1990- EPA PLANS

RE: RFI Workplans

RE: Ground Water Monitoring at Ciniza Refinery Land Treatment
Unit - Your letter of 4/23/86

Subject: Annual ground water monitoring report for January 1
to December 31, 1985, Facility EPA I.D. Number FNMD 00033321

GENERAL SPECIFICATIONS FOR
NEW MONITOR WELL MW-3

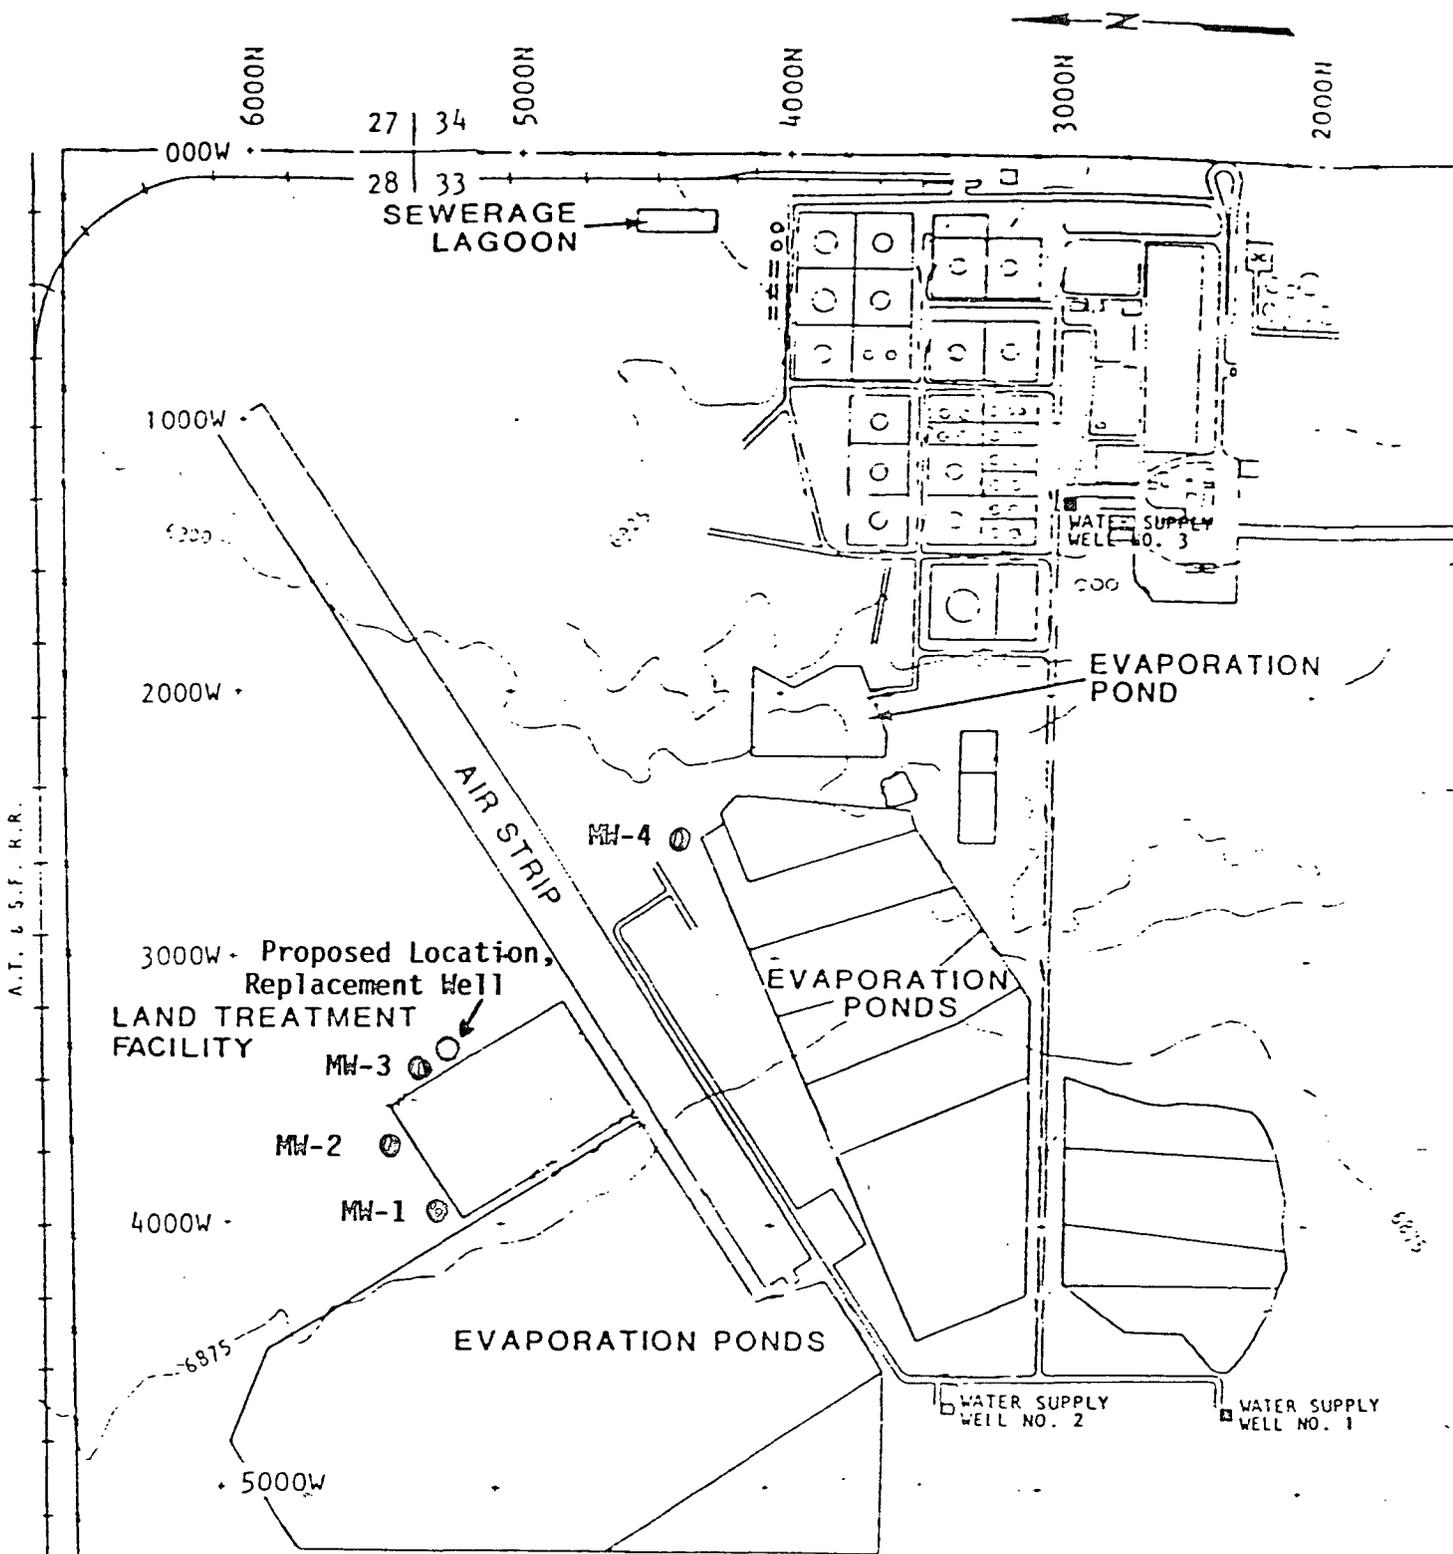
For the reasons discussed above, Giant agrees to undertake your option #1 of a replacement for MW-3 in the Sonsela and semi-annual monitoring of SMW-4, SMW-5, SMW-6 and OW-24 for:

All the parameters required under NMHWMR Section 206.C.1c.(2) will be analyzed in the new well (replacement of MW-3) following development and stabilization. This well will then replace MW-3 in the ongoing semi-annual RCRA monitoring program. The old MW-3 will then be plugged and abandoned. With the exception of the additional wells to be monitored as described above, the original sampling and analysis plan as has been followed since 1981 (according to the original part B application) will continue.

This new well will be installed near MW-3 on or before July 20, 1986, and sampled on or before August 8, 1986.

- a. A new well must be installed near the location of MW-3 and must be completed within the Sonsela. After development of the new well, samples must be taken from it and from MW-1, MW-2 and MW-4. The samples must be analyzed for all parameters required under 206.C.1c.(2). If the analytical values for the new well fall within the range of values for the other wells, then the new well can simply be incorporated into the ongoing semi-annual sampling program. If the results indicate that the new well has a different water quality from the other MW wells, further investigations will be necessary to determine the reason for the difference.

FIGURE 5
Correlation Between Conductivity Values and Sodium + Chloride + Sulfate, Giant Ciniza Refinery Ground-Water Monitoring Wells.

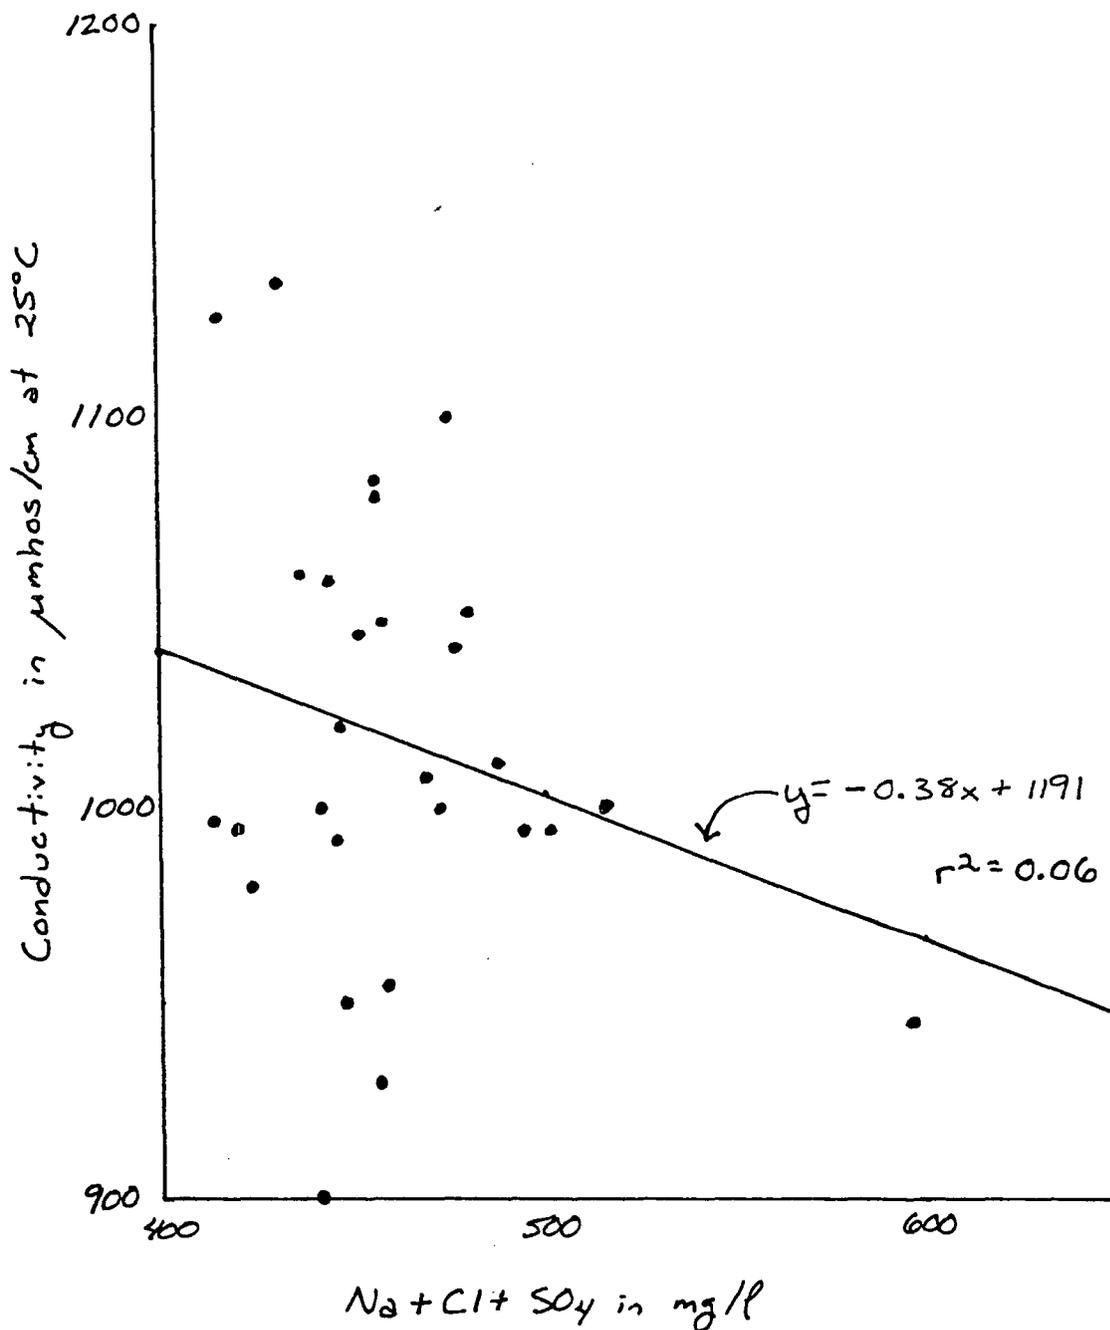
- 2) Conductivity is most related to concentrations of the major ions -- sodium, potassium, calcium, magnesium, chloride, sulfate, carbonate and bicarbonate. Values for sodium, chloride and sulfate show no increase over the data period (analyses for the other ions are not required). Also, there is little correlation between the sodium/chloride/sulfate total and conductivity, as shown in figure 5. This suggests that the conductivity values are more dependent on laboratory analytical bias than on the actual concentrations of the various parameters which contribute to conductivity.

As shown by this "scattergram", there is essentially no correlation. Linear regression gives a correlation coefficient value of only 0.06 (for absolute correlation, $r^2 = 1.00$). Removing the apparent outlier point (597,945) actually reduces the correlation ($r^2 = 0.01$).
